Service Bulletin

Sept. 24, 1959

No. 59-100

ROCKER
SHAFT
IDENTIFI-
CATION

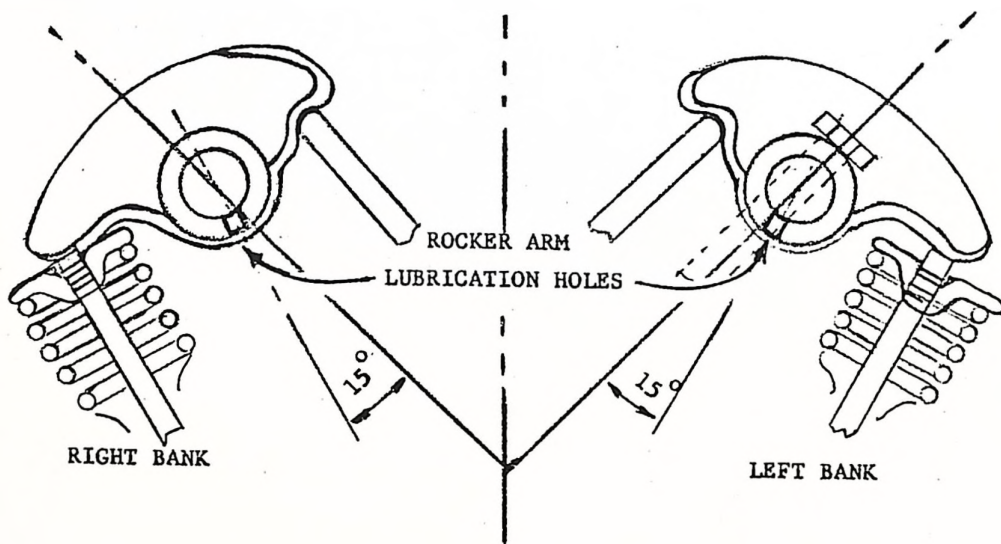
During the latter part of 1959 engine production, starting with engine numbers approximately MR383-17000, MR413-16000, the arrow identification on the rocker shafts was omitted. However, the rocker shafts can be readily identified by other means to allow correct assembly.

Should it be necessary to remove or replace the rocker shafts on 1959 Chrysler and Imperial engines of later engine numbers, and one or both rocker shafts does not carry the arrow identification, the following procedure will insure correct installation:

Install the rocker shafts so that the 3/16 inch dia. rocker arm lubrication holes point downward into the rocker arm and so that the 15° angle of these holes points toward the valve end of the rocker arms. See sketch below:

Note: The 15⁰ angle of the rocker arm lubrication holes is determined from the center line of the bolt holes through the shaft which are used to attach the shaft and brackets assembly to the cylinder head.

It is important that the rocker arm shafts are installed, as outlined above, otherwise excessive oil spray and improper lubrication of the valve train components can result.
